ACCESS REPORT

Reference Number: 23174

Client: DKT Studio

Site Address: 16-18 Stapleton Parade, St Marys, NSW

[Image description: Plan of carparking above shows the provision of Accessible parking spaces]

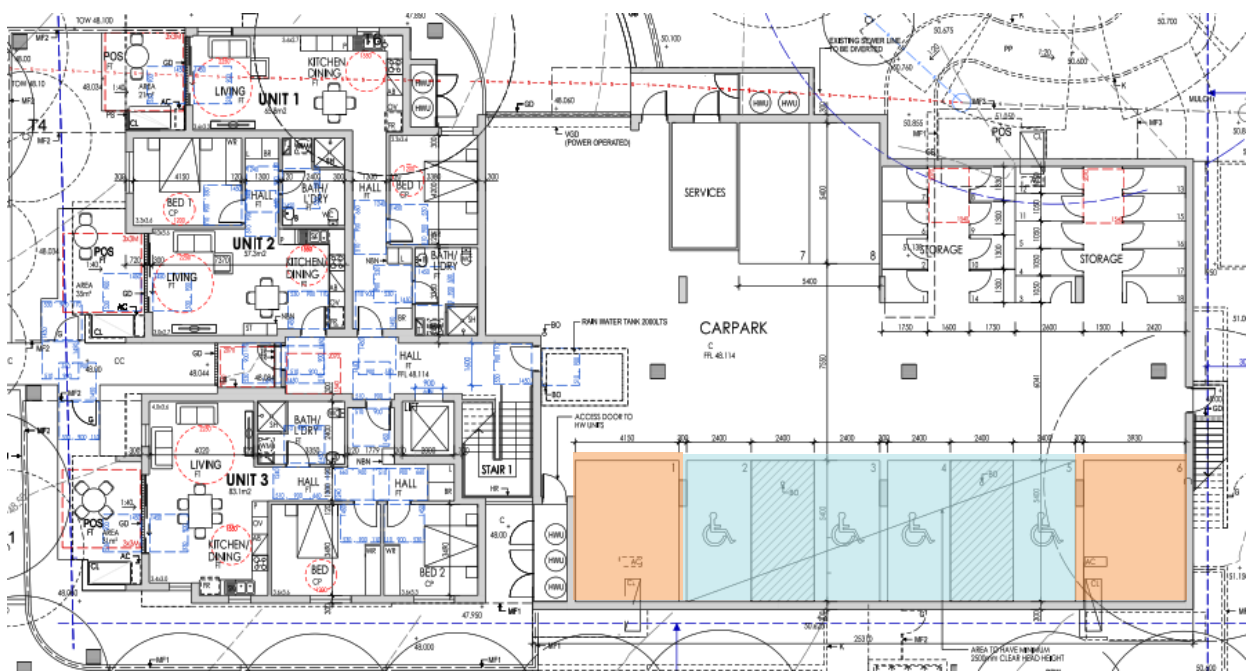
4 Accessible parking spaces and 2 x 3.8M wide parking spaces are provided in the development.

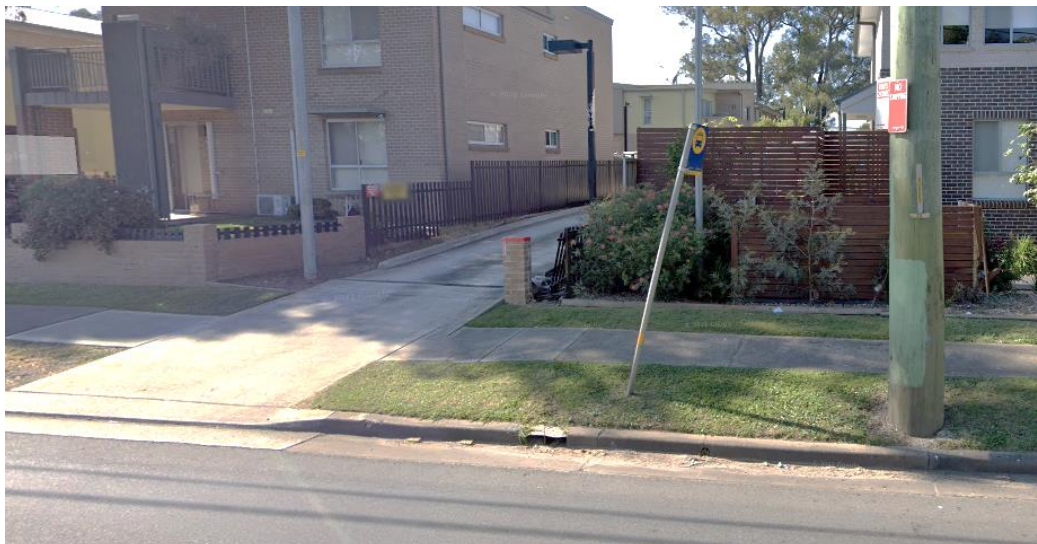
Pedestrian links from the subject site to the nominated bus stops have been provided via kerb ramps at dedicated established crossings. Note that the nomination of the bus stops is by others.

FOOTPATH LONGITUDINAL
CHAINAGE 0.000 TO
HZ SCALE 1:200 VER S

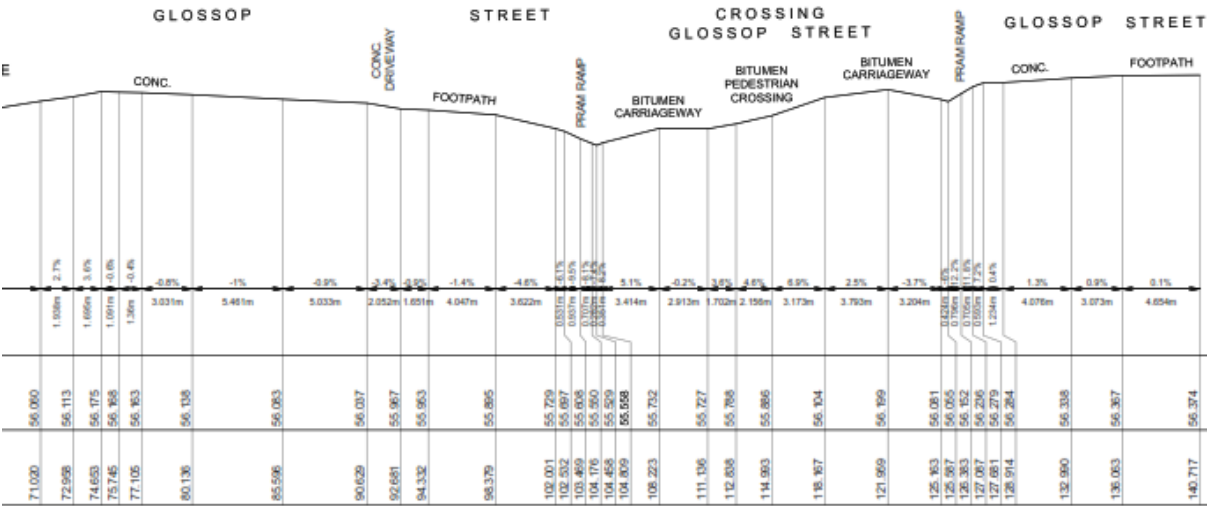
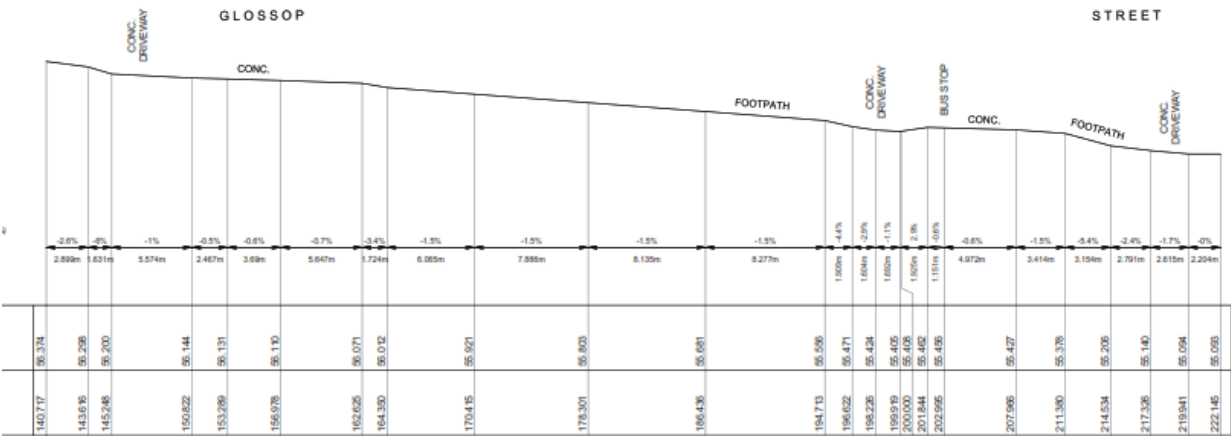
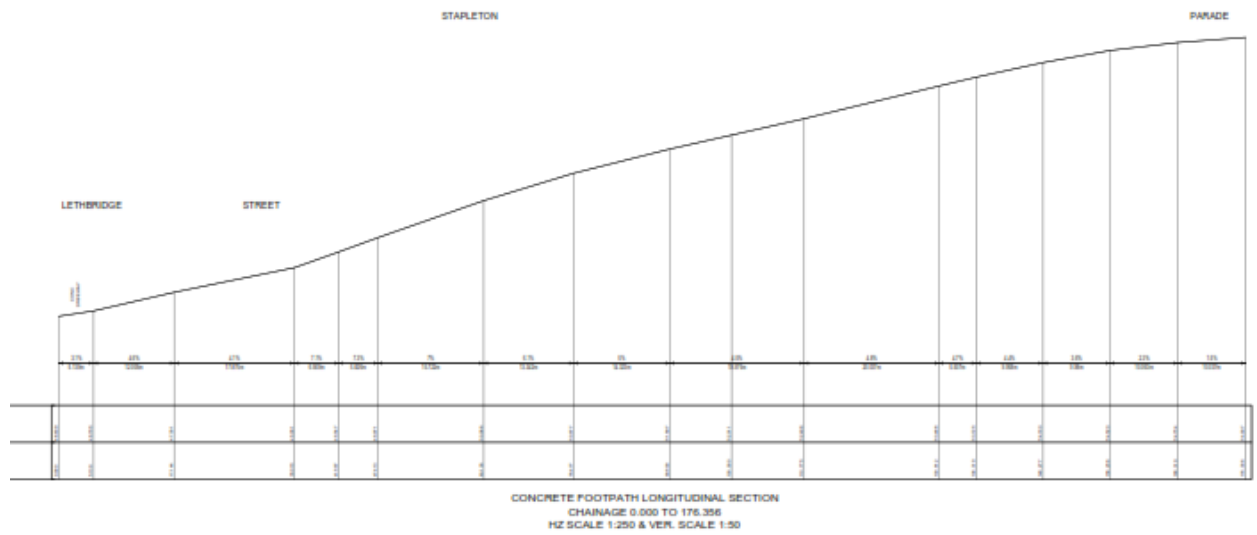
A detailed longitudinal grade survey has been provided that indicate grades of the pathways being within the range as required by the SEPP

All grades are within acceptable range as specified in the SEPP.

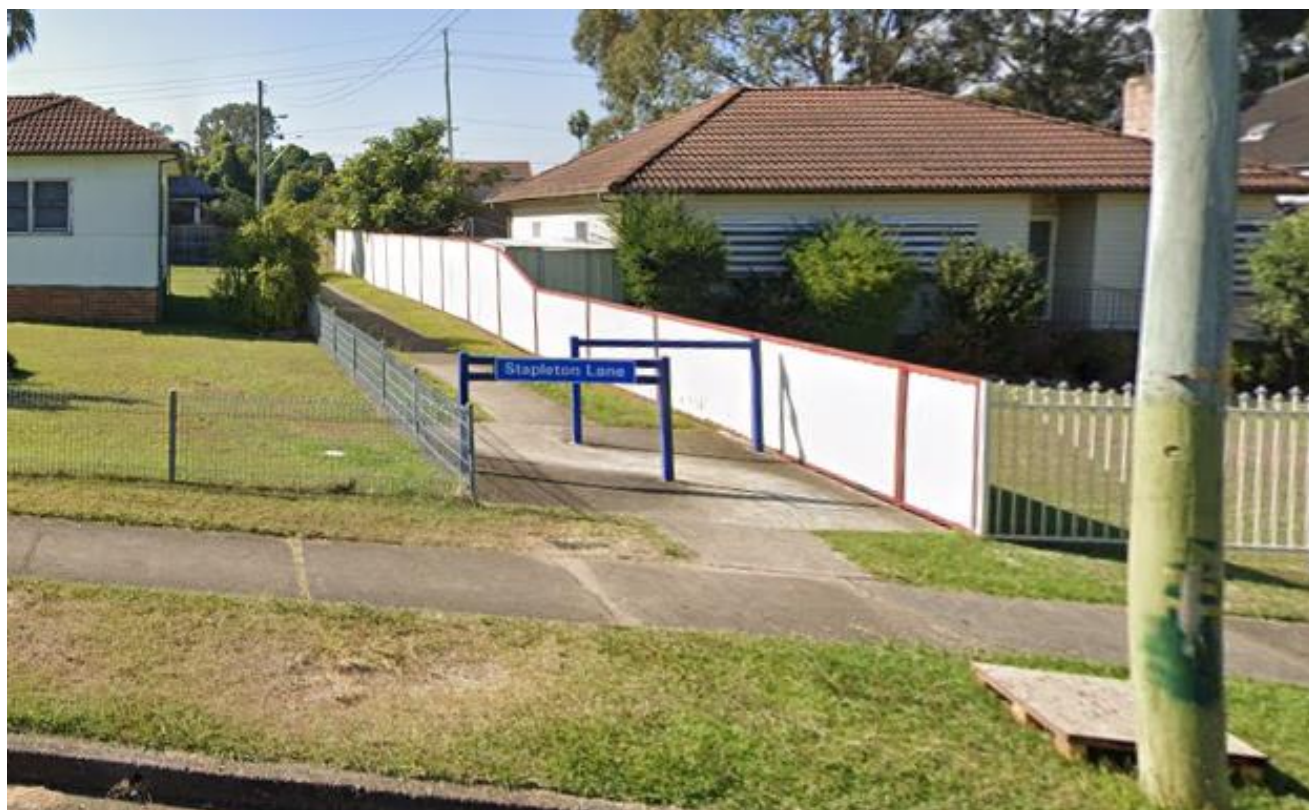
Barriers (in blue above) to be removed or adjusted for easier wheelchair access
